NEW DRAWER HEATER

Built-in 55cm oven with warmer drawer from Schwanden production 1997 - 2010 up to and including serial no. 0 25

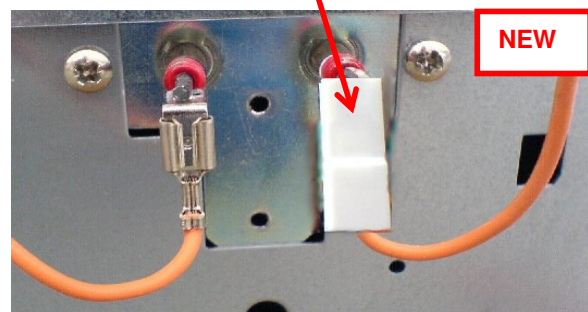
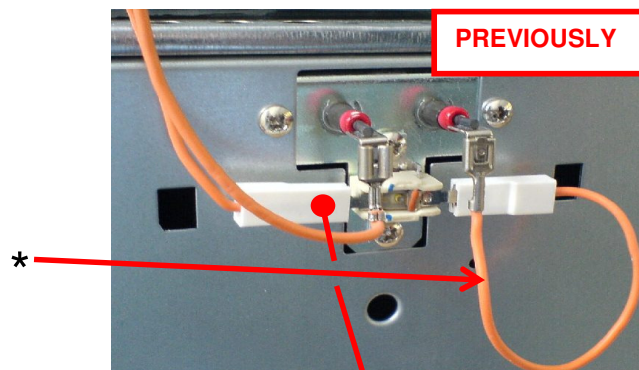
Plates do not get warm enough / does not heat up enough.

Large temperature fluctuation of warmer drawer due to slow regulation by the temperature switch. temperature switch

- From serial no. 0 26 old warmer drawer 400V-480W, ET-Nr. 387 13 22-01 / 6 replaced by the new warmer drawer 400V-350W, ET-Nr. 5610855289 (inc. service information. Warmer identical in construction to the previous 480W version. Distinguishing feature: 480W with RED ceramic bead, new 350W with ORANGE bead).
- 55°C temperature switch no longer necessary.

Modify units up to and including serial no. 0 26 as follows:

- Exchange warmer drawer (new 350W)
- Remove 55°C temperature switch.
- Remove the wire between the temperature switch and warmer drawer. (*)
- Error code 118 / 28
